La Vista City Centre Theater Preliminary Plat

RECOMMENDATION REPORT

CASE NUMBER: PSPP 19-0001

RE: Preliminary Plat – Initial Review
La Vista City Centre Theater

SHEET
C1.1

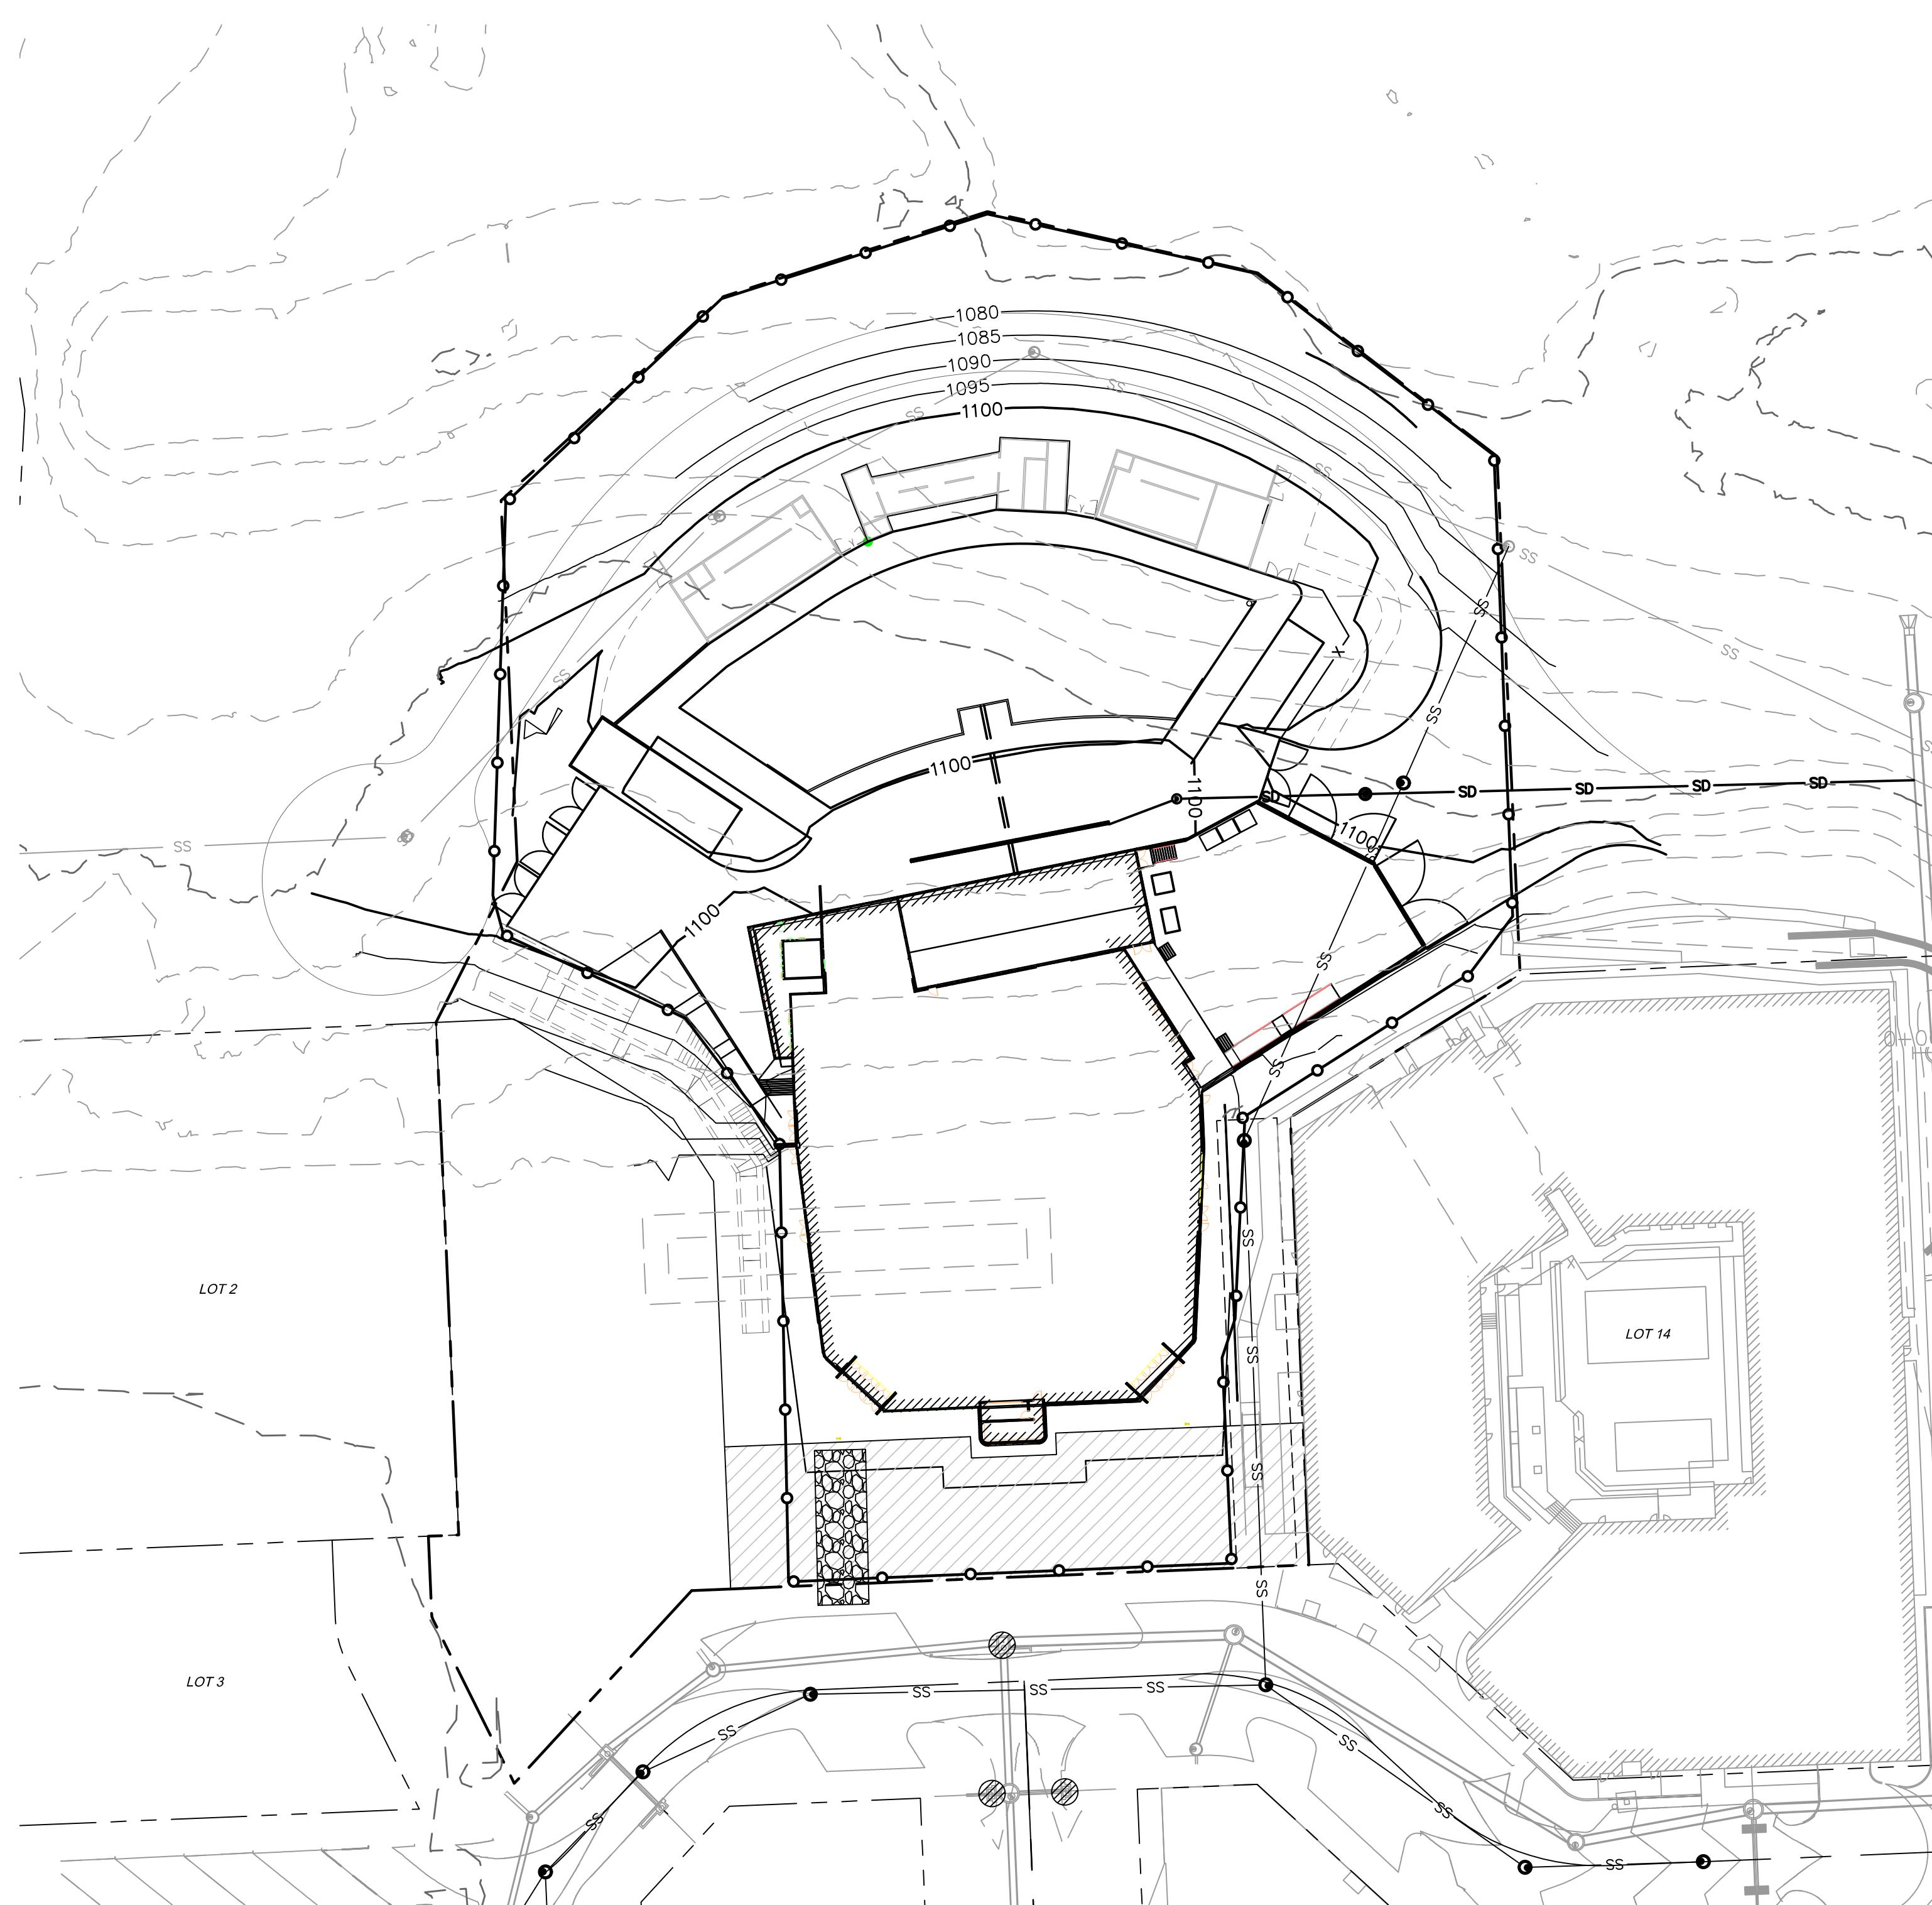
1. Article 3.03.02: Due to the nature of this preliminary plat please include proposed floor elevations on Lot 14 and on Lot 1. This should include the main floor elevation on Lot 14 and the bottom floor, stage and upper floor elevations on Lot 1.

2. Article 3.03.06: Please provide a legal description of the area being platted, including acreage of the proposed development.
3. Article 3.03.07: The location of the existing edge of normal water surface in the Civic Center Park lake needs to be shown as this affects the boundary of proposed Lot 2. The location of the relocated sanitary outfall sewer north of Lots 1 and 2 should be shown. Both of these can be based on the TD2 topographic survey of the "interface" area dated January 31, 2019. If Olsson does not already have a copy of this survey, the City will make arrangements for Olsson to receive it.

4. Article 3.03.09: The proposed lot areas should be identified in square footage and not acres since appraisals and negotiations will need the areas in square feet.

5. Article 3.03.10: An easement for the public sanitary sewer through Lots 1 and 2 to the outfall sewer needs to be shown. Any storm sewer easements (public or private) proposed over Lots 1 through 3 need to be shown. There should be notations in regards to any proposed blanket easements for ingress and egress amongst the lots and for public benefit.

6. Article 3.03.12: It appears that an existing sanitary sewer easement and an existing storm sewer easement will need to be released. Please add notations indicating the intent in regards to these easements.

7. Article 3.03.13: Please provide any established floodplain overlay lines. Per Zoning Ordinance Section 5.18, the development's proximity to the delineated Zone A Floodplain will most likely require a Floodplain Development Permit be obtained as to ensure flood hazards are analyzed as to satisfy the conditions of the aforementioned zoning ordinance.

1. Article 3.03.02: Due to the nature of this preliminary plat please include proposed floor elevations on Lot 14 and on Lot 1. This should include the main floor elevation on Lot 14 and the bottom floor, stage and upper floor elevations on Lot 1. **Response: Elevations have been provided.**

2. Article 3.03.06: Please provide a legal description of the area being platted, including acreage of the proposed development. **Response: Legal description has been provided.**

3. Article 3.03.07: The location of the existing edge of normal water surface in the Civic Center Park lake needs to be shown as this affects the boundary of proposed Lot 2. The location of the relocated sanitary outfall sewer north of Lots 1 and 2 should be shown. Both of these can be based on the TD2 topographic survey of the "interface" area dated January 31, 2019. If Olsson does not already have a copy of this survey, the City will make arrangements for Olsson to receive it. **Response: This was coordinated with TD2 and the boundary has been revised to accommodate the edge of waterway. Relocated sanitary sewer has also been provided.**

4. Article 3.03.09: The proposed lot areas should be identified in square footage and not acres since appraisals and negotiations will need the areas in square feet. **Response: This has been updated**

5. Article 3.03.10: An easement for the public sanitary sewer through Lots 1 and 2 to the outfall sewer needs to be shown. Any storm sewer easements (public or private) proposed over Lots 1 through 3 need to be shown. There should be notations in regards to any proposed blanket easements for ingress and egress amongst the lots and for public benefit. **Response: This easement has been added for the existing line through the lot.**

6. Article 3.03.12: It appears that an existing sanitary sewer easement and an existing storm sewer easement will need to be released. Please add notations indicating the intent in regards to these easements. **Response: This will be shown as released on the preliminary plat.**

7. Article 3.03.13: Please provide any established floodplain overlay lines. Per Zoning Ordinance Section 5.18, the development's proximity to the delineated Zone A Floodplain will most likely require a Floodplain Development Permit be obtained as to ensure flood hazards are analyzed as to satisfy the conditions of the aforementioned zoning ordinance. **Response: Floodplain line has been shown. If permitting is needed, this will be provided with the construction plans.**

SHEET
C3.1

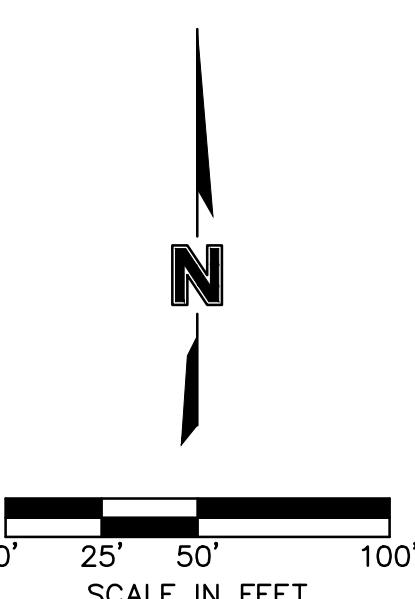
9. Article 3.03.16: On Sheet C3.1 some notations or illustrations are needed to address this requirement. The overall disturbed area will exceed five acres and add notations that sediment traps/basins, silt fences, and inlet filters will be utilized for sediment control at a minimum. Dependent on which entity undertakes the site preparation grading for these lots will identify which erosion control permit needs to be modified in Permix to include this area.

11. Article 3.03.20:
 - a. Per Item 2 above, show the sanitary outfall sewer.
 - b. The storm drainage plan (Sheet C3.1) needs to include conceptual information for proposed water quality treatment. The 2-year peak runoff increase can be addressed in the storm water detention facility in Civic Center Park.

- c. Information concerning a PCSMP plan needs to be provided on Sheet C3.1. This would include reference to the current plan for PCSMP No. 20170324-3736P and particularly Note 2 on Exhibit "B". Notations as to how runoff from the proposed truck dock and bus parking aprons will be treated are needed at a minimum. These locations have the most potential for pollutants that could affect the lake.

9. Article 3.03.16: On Sheet C3.1 some notations or illustrations are needed to address this requirement. The overall disturbed area will exceed five acres and add notations that sediment traps/basins, silt fences, and inlet filters will be utilized for sediment control at a minimum. Dependent on which entity undertakes the site preparation grading for these lots will identify which erosion control permit needs to be modified in Permix to include this area. **Response: Note has been added.**

11. Article 3.03.20:
 - a. Per Item 2 above, show the sanitary outfall sewer. **Response: Provided.**
 - b. The storm drainage plan (Sheet C3.1) needs to include conceptual information for proposed water quality treatment. The 2-year peak runoff increase can be addressed in the storm water detention facility in Civic Center Park. **Response: Storm quality structure has been provided.**

- c. Information concerning a PCSMP plan needs to be provided on Sheet C3.1. This would include reference to the current plan for PCSMP No. 20170324- 3736P and particularly Note 2 on Exhibit "B". Notations as to how runoff from the proposed truck dock and bus parking aprons will be treated are needed at a minimum. These locations have the most potential for pollutants that could affect the lake. **Response: PCSMP information has been added to sheet C3.1 and PCSMP # has been added. A trench drain has been added along the front of the truck dock and will tie in before the vortex system.**

Revised Acreage Draining to Basins: 1.01 acres

Required Water Quality Treatment Volume: (Drainage Area) * 1,815 CF/AC
(1.01 AC) * 1,815 CF/AC = 1,833 CF

Water Quality Treatment Volume to be Provided: 1,833 CF
